BOARD ACTION REPORT – APPEALABLE ITEM

Project Name: Townhomes at 214 4th

SITE PLAN REVIEW AND APPEARANCE BOARD STAFF REPORT

Application Type: Class V Site Plan, Landscape Plan, Architectural Elevations and Landscape Barrier Waiver – Townhomes at 214 4th

Proposed Entry court Plan & Streetscape Detail
3/16" SC

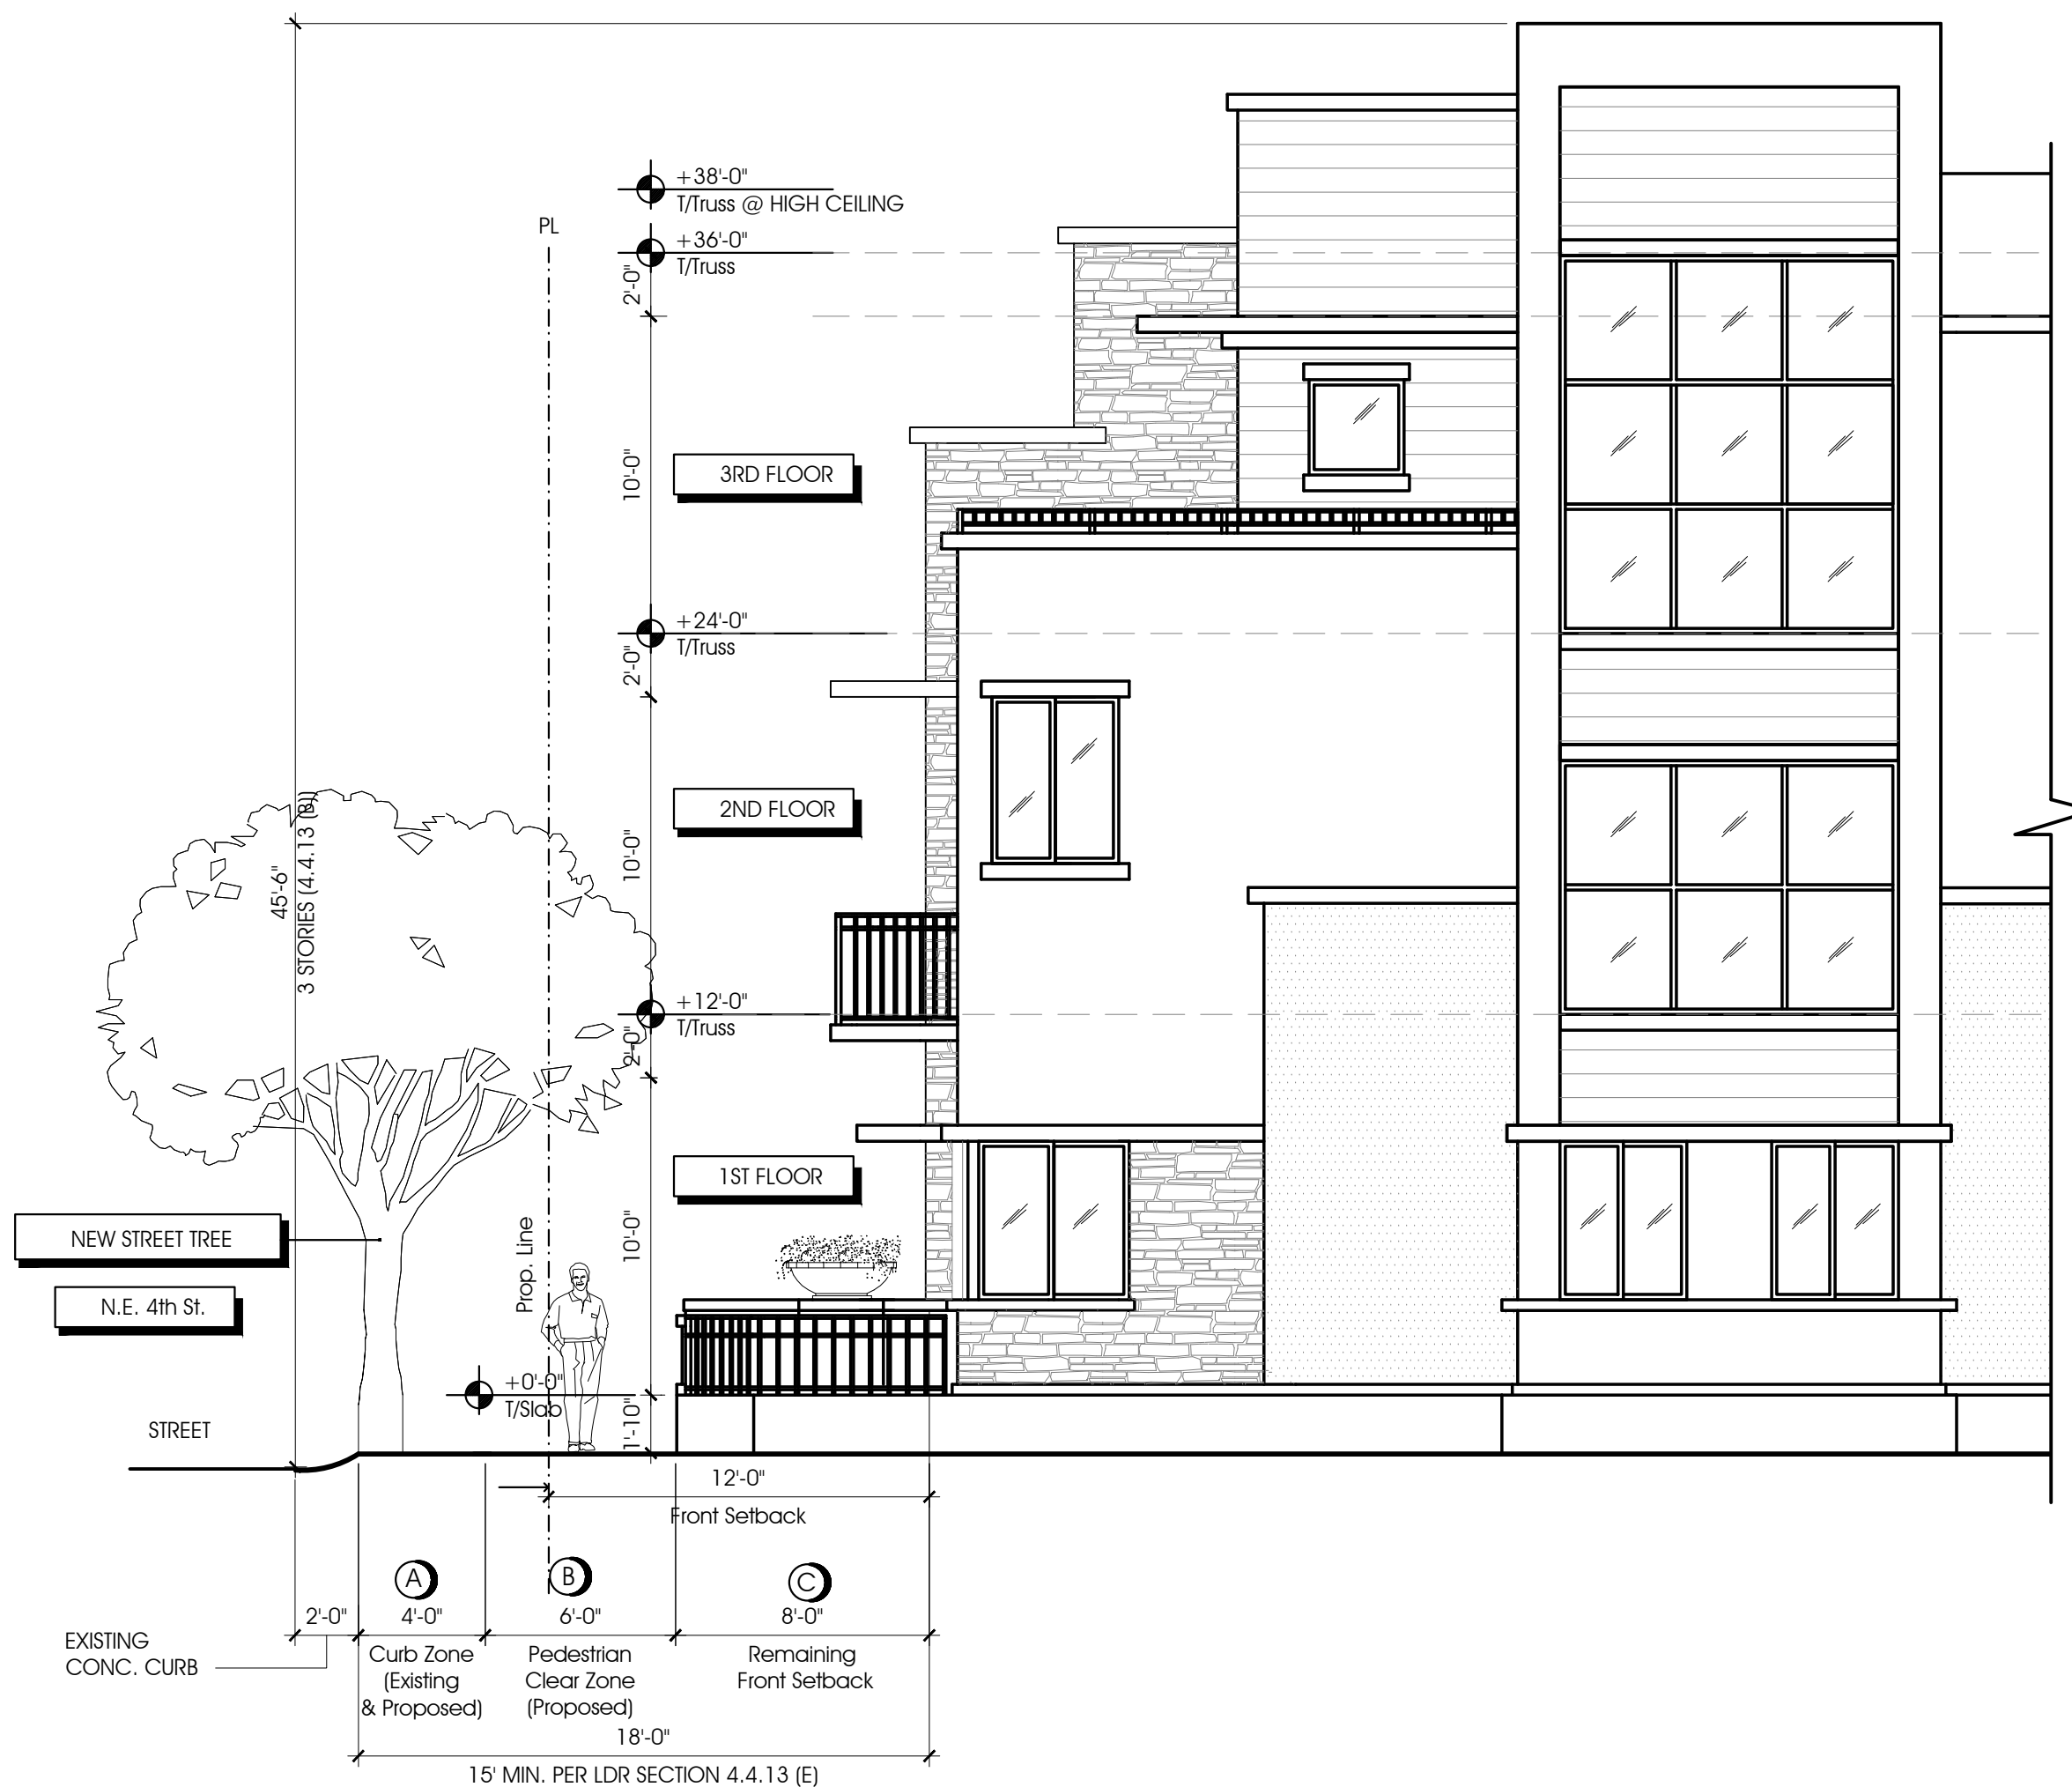
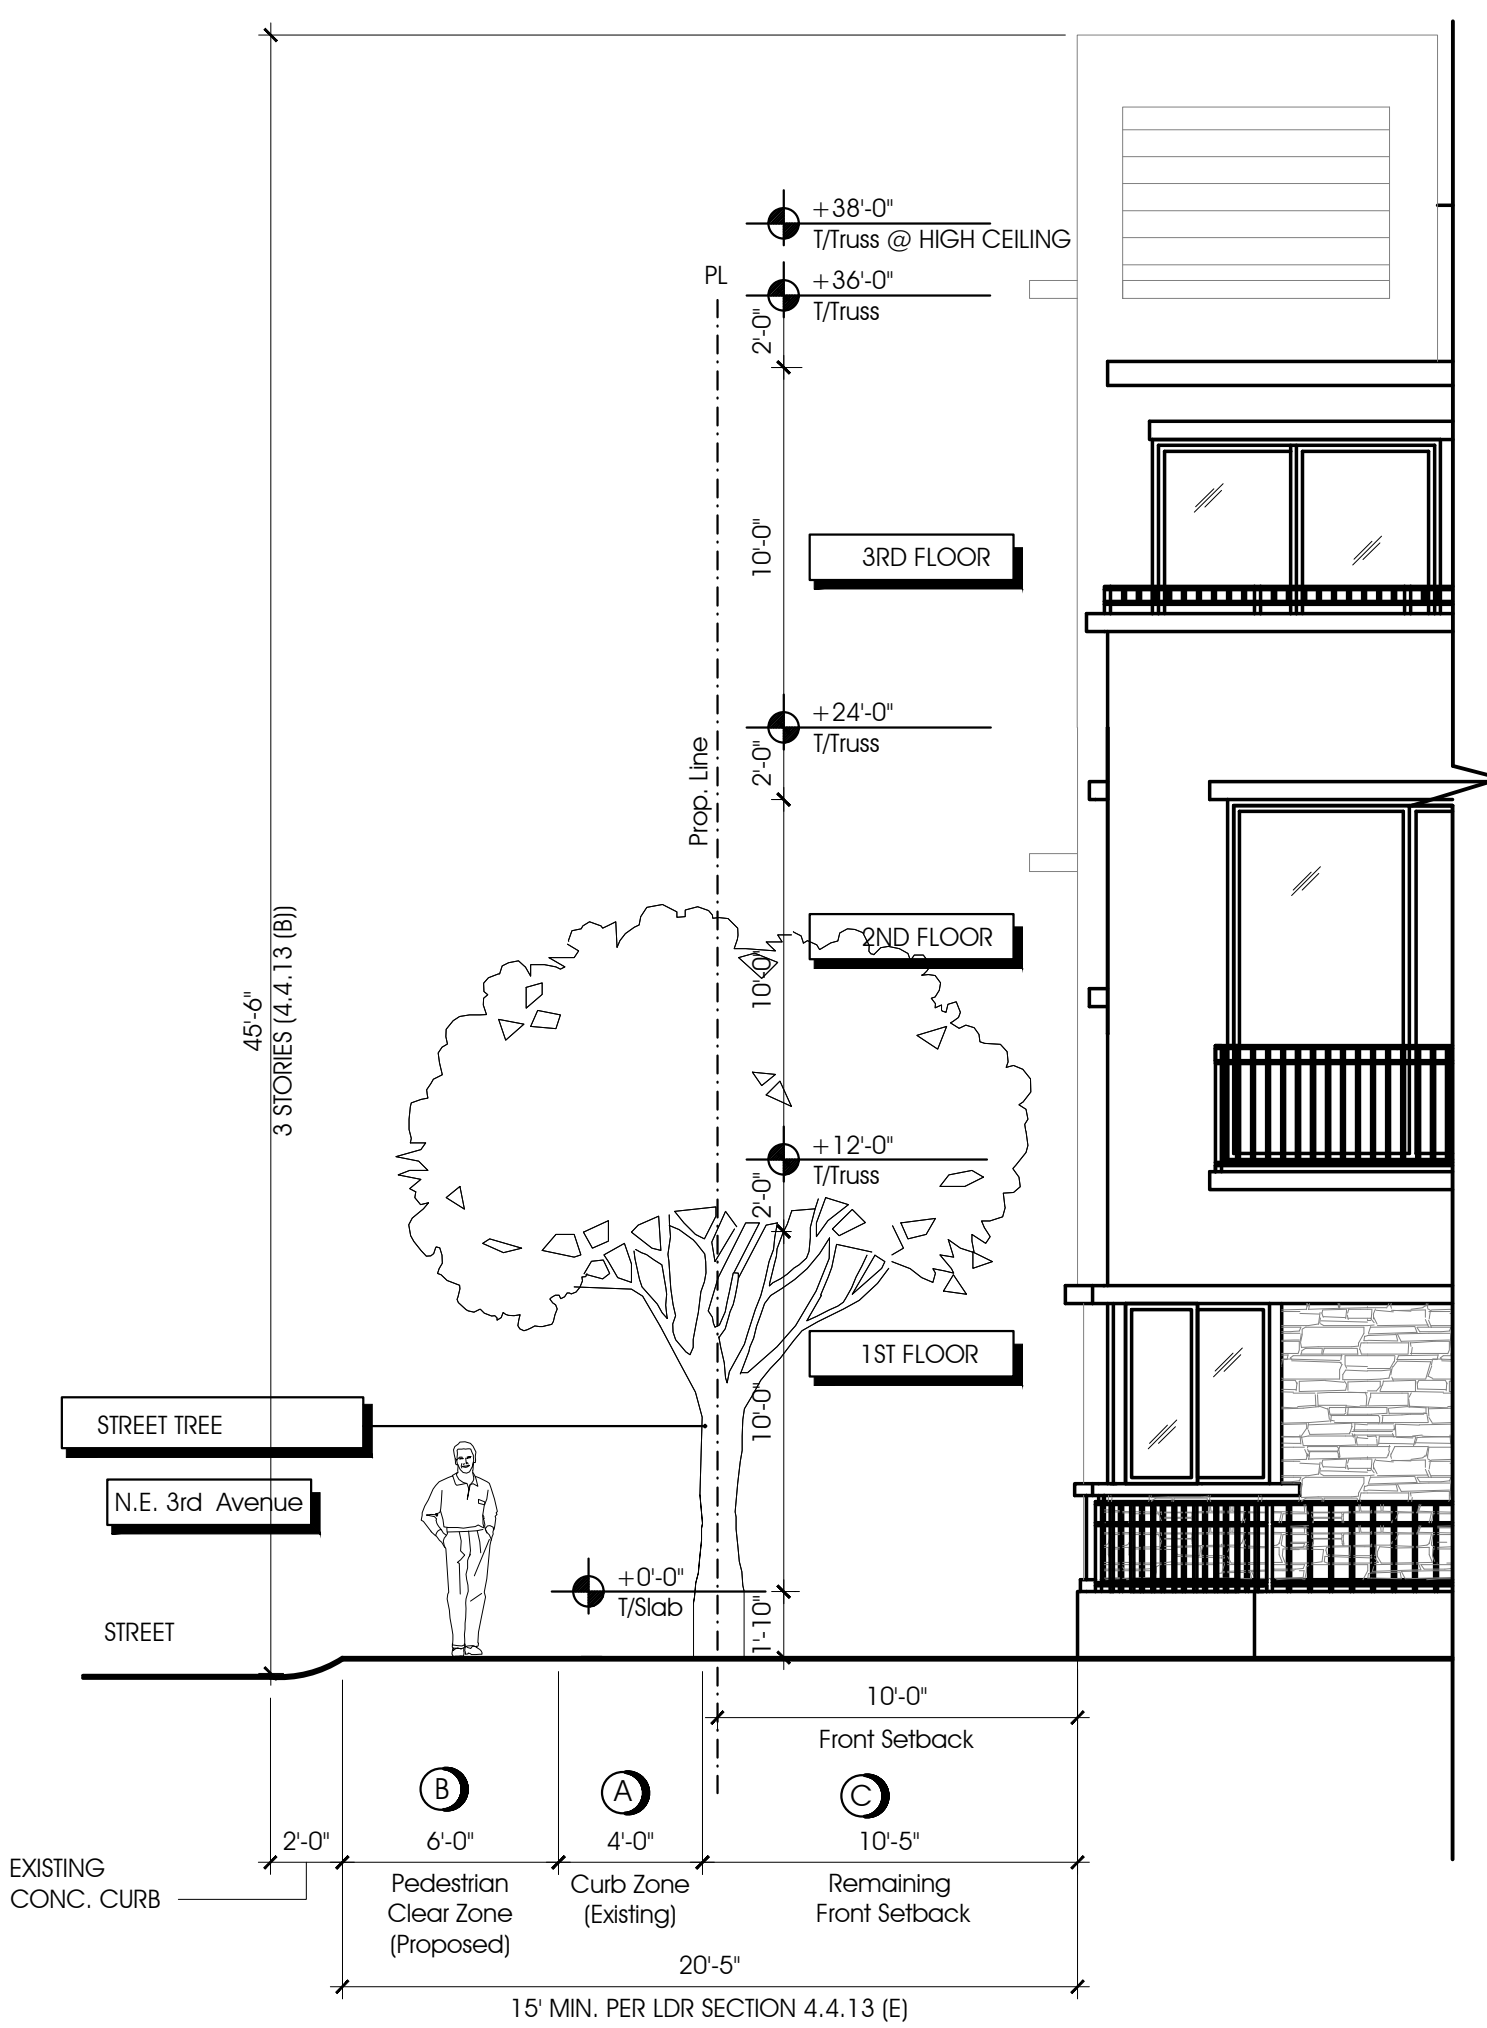
Pursuant to LDR Table 4.4.13(B), the first habitable floor for residential uses within the Railroad Corridor Sub-district must be a minimum of 18 inches above the adjacent sidewalk. The minimum required height provides a level of privacy to the residential uses located along the sidewalk. The minimum floor height of the first floor of residential dwellings is 10 feet and each subsequent story must be 9 feet. For the frontage type, a stoop is being proposed. A stoop must have a minimum height of 1 foot with a maximum height of 4 feet. Although the stoop may encroach into the setback a maximum of 5 feet, no encroachments of the stoop are permitted within the pedestrian clear zone or the curb zone. The proposed structures meet these standards.

Stoops	Required	Proposed
Building Setback	10 ft. min/ 15 ft. max.	11 ft. – 7".
Depth	5 ft. min/8 ft. max.	5 ft.
Width	4-ft min / N/A max.	6 ft.
Floor Elevation	1 ft. min/ 4 ft. max.	>1-ft.
Allowable Encroachment	5 ft. max	<5-ft.
